### REGENCY CENTRE LOT 1, JSP 18-35

Consideration of the request of Oliver/Hatcher Construction for Preliminary Site Plan and Storm Water Management Plan approval for a new 34,782 square foot Research/Development/Office building. The subject property (25150 Regency Drive) contains 2.99 acres and is located in Section 24, north of Grand River Avenue and west of Haggerty Road, in the I-1, Light Industrial District.

## PLANNING REVIEW

**Planning Review**  
**Regency Centre Lot 1**  
 JSP 18-35

A.201

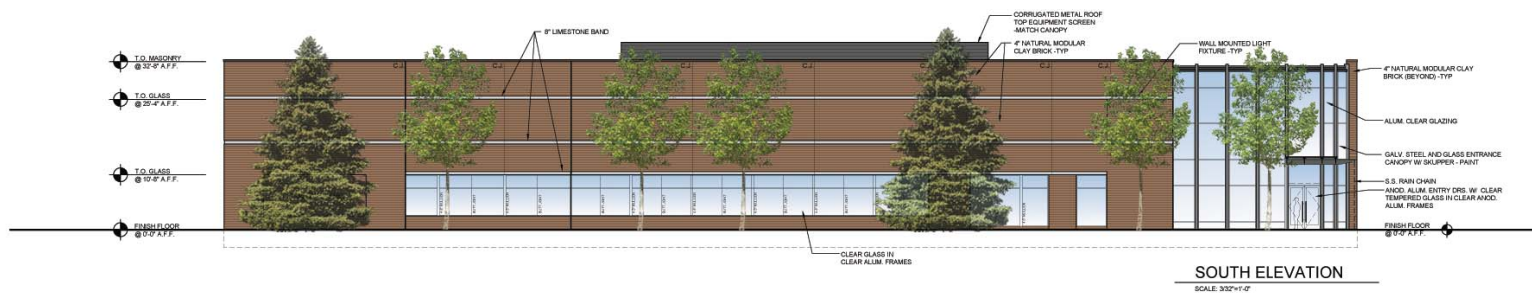
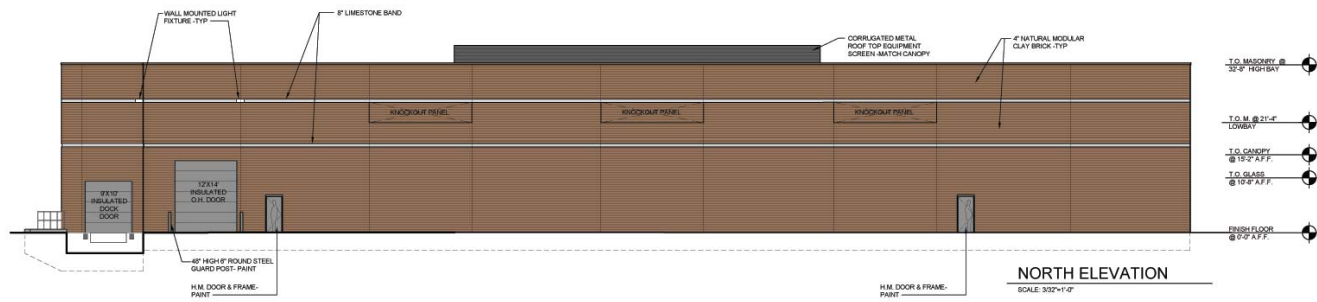
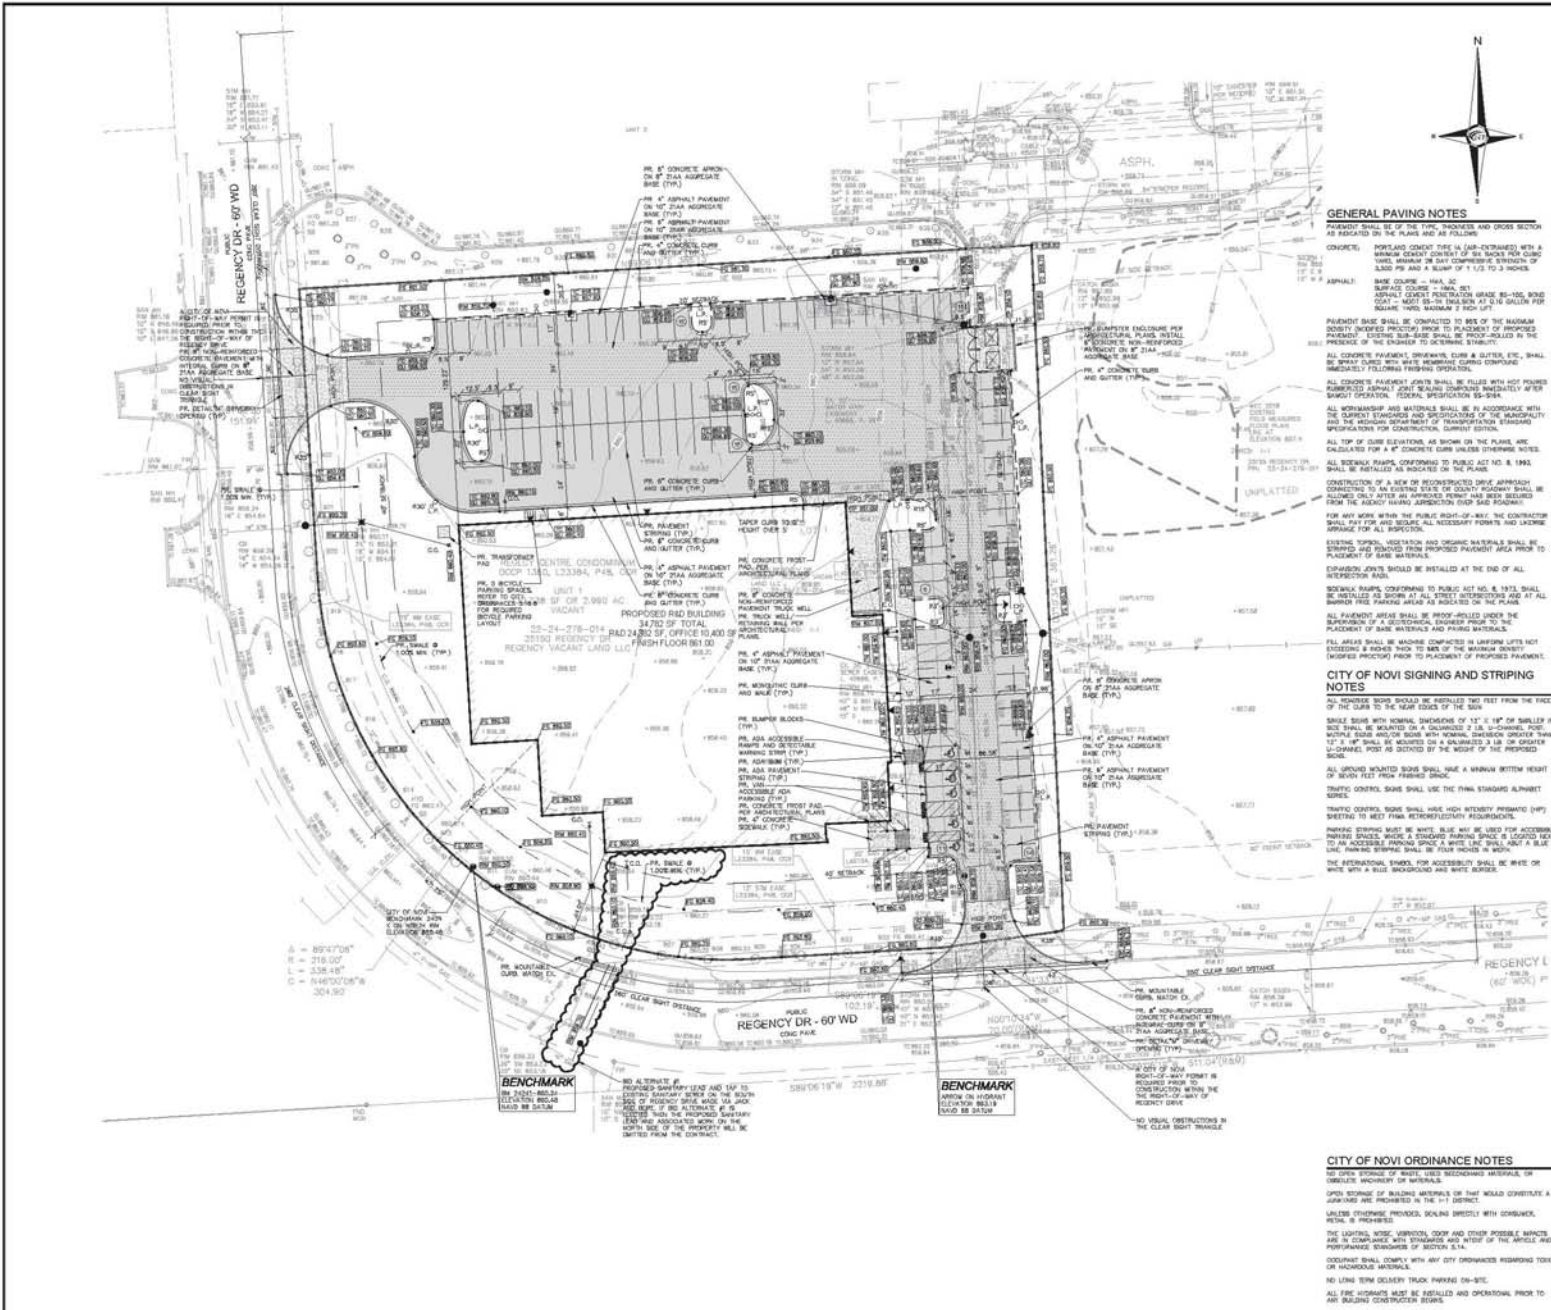
- A note will be added to sheet A.201 stating that "All Roof Top Appurtenances will be screened in accordance with the applicable facade regulations and shall not be visible from any street, road or adjacent property."
